EKI TECHNICAL PRESENTATION #34

COSUMNES SUBBASIN GSP DEVELOPMENT

COSUMNES SUBBASIN WORKING GROUP MEETING

RESPONSE TO PUBLIC COMMENTS (1 OF 12)

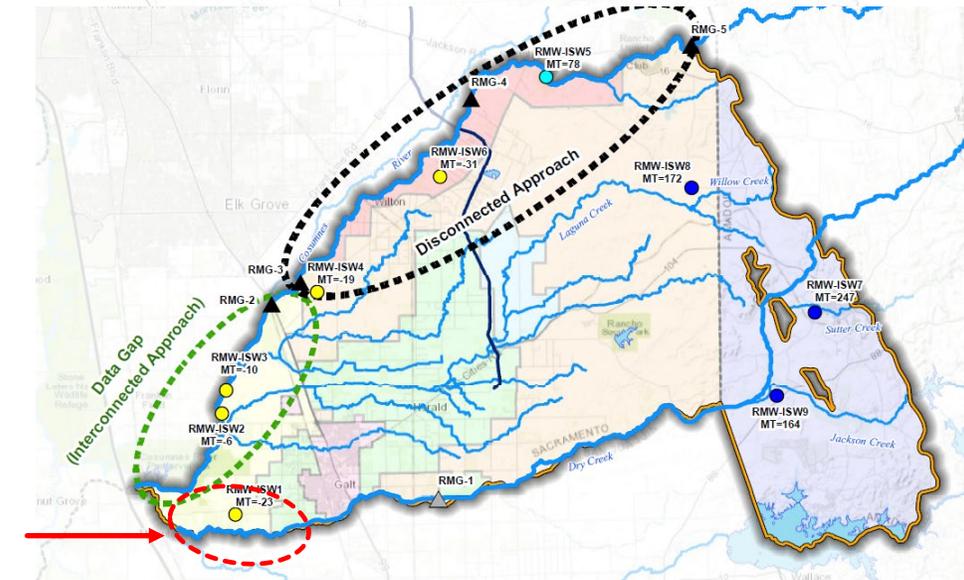
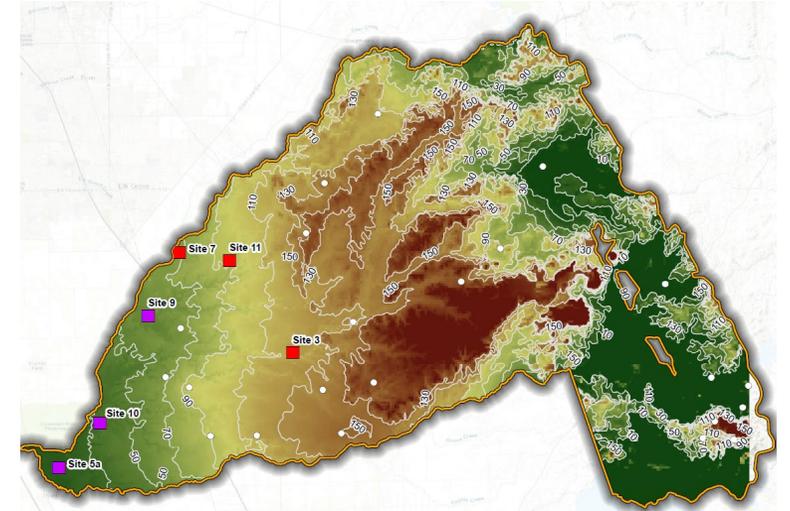
Comment #5: **Info on the past, current and proposed budget.** (Tish Espinosa)

Response: Update Table PI-1.

Explanation: *The budget for GSP development is included in the Final Cosumnes Cost Share Agreement: <https://cosumnes.waterforum.org/wp-content/uploads/2018/08/4-Cosumnes-Cost-Share-Agmt-52450-Revised-Draft-2018-08-10.pdf> . The estimated costs to implement the GSP are found in Table PI-1. These costs have been updated as a result of on-going efforts by the Working Group.*

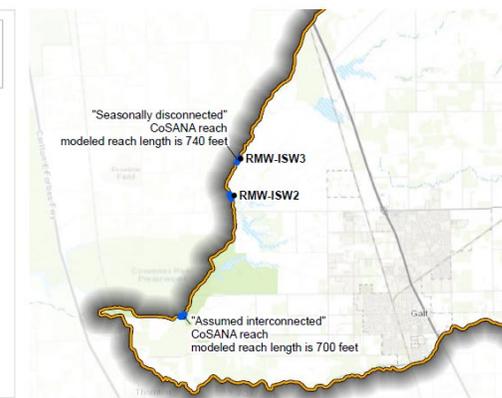
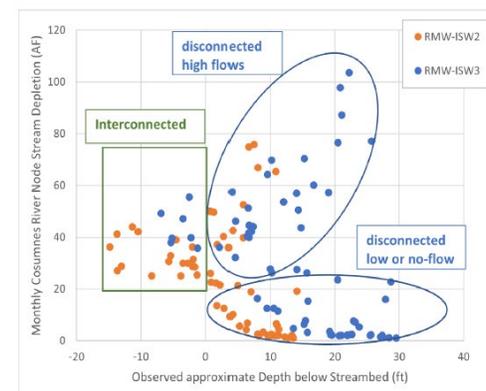
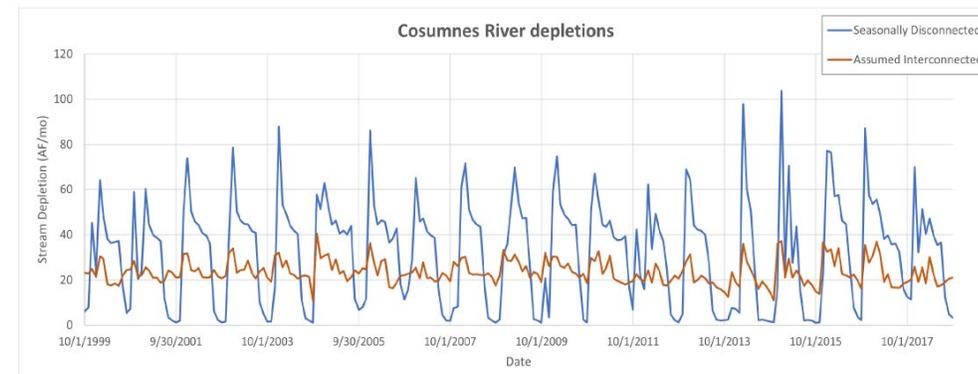
Comment #44: Table presenting the long-term average monthly depletions, in both the interconnected and disconnected reaches, would improve clarity. Quantifying depletions by month and reach will improve understanding of depletions. (CDFW)

Response: Add table of monthly model-calculated depletions for the two reaches presented in Figure GWC-16.

Explanation: *The information presented in Figure GWC-16 is a combination of measured and model-calculated results for two lengths of river (each ~700 feet in length). These river sections are adjacent to shallow monitoring wells whose water level data were used to classify them as “seasonally disconnected” and “assumed interconnected.” This is explained in Figure GWC-16, but not repeated in the text. The text will be modified accordingly.*

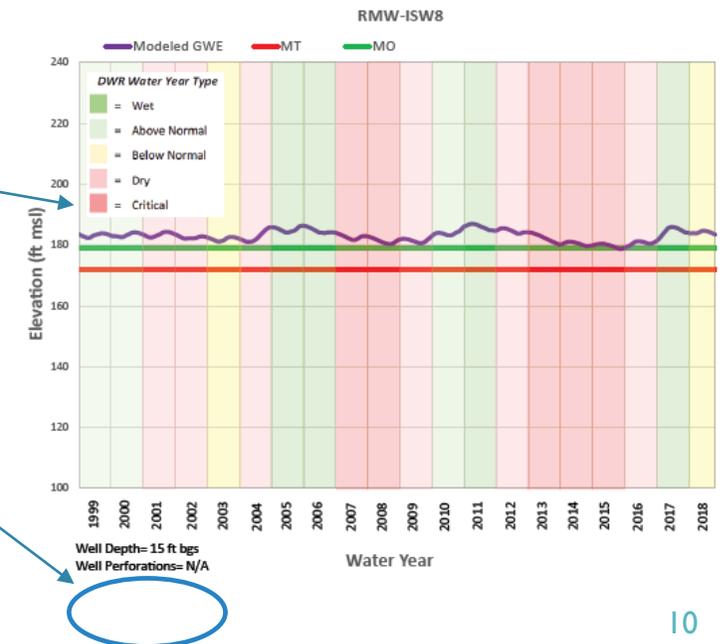
Comment #51: **Without a ground surface elevation reference, it is difficult to determine the depth to groundwater below the ground surface for evaluation of potential impacts to groundwater dependent ecosystems. (CDFW)**

Response: Post numeric value of ground surface elevation on each hydrograph.

Figure 14. GDE Pulse derived NDVI and NDMI trends for NCCAG GDEs in the Cosumnes Subbasin and average annual precipitation.

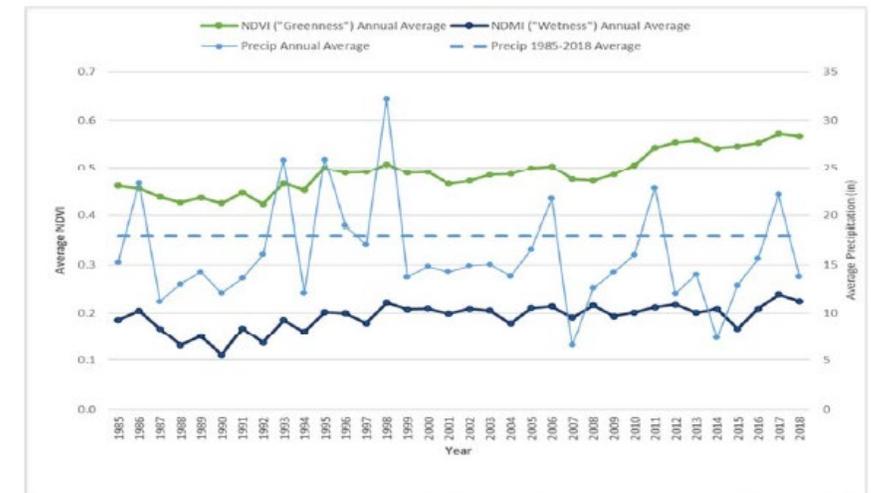
Comment #50: GSP states that other indicators of GDE health will be monitored in the subbasin (e.g., Normalized Difference Vegetation Index (NDVI)), it is unclear how those metrics will be used by the Working Group to determine if a management response is needed, because no ‘trigger threshold’ is defined. (CDFW)

Response: Add to implementation process to determine triggers based on monitoring data as part of 5-year update.

Explanation: *Monitoring plan already includes groundwater levels, climate, satellite imagery, and timing and magnitude of Cosumnes River flow (e.g. TNC GDE Pulse). Evaluation of these data coupled with periodic site visits to verify conditions of GDEs will be considered to develop triggers and the required response.*
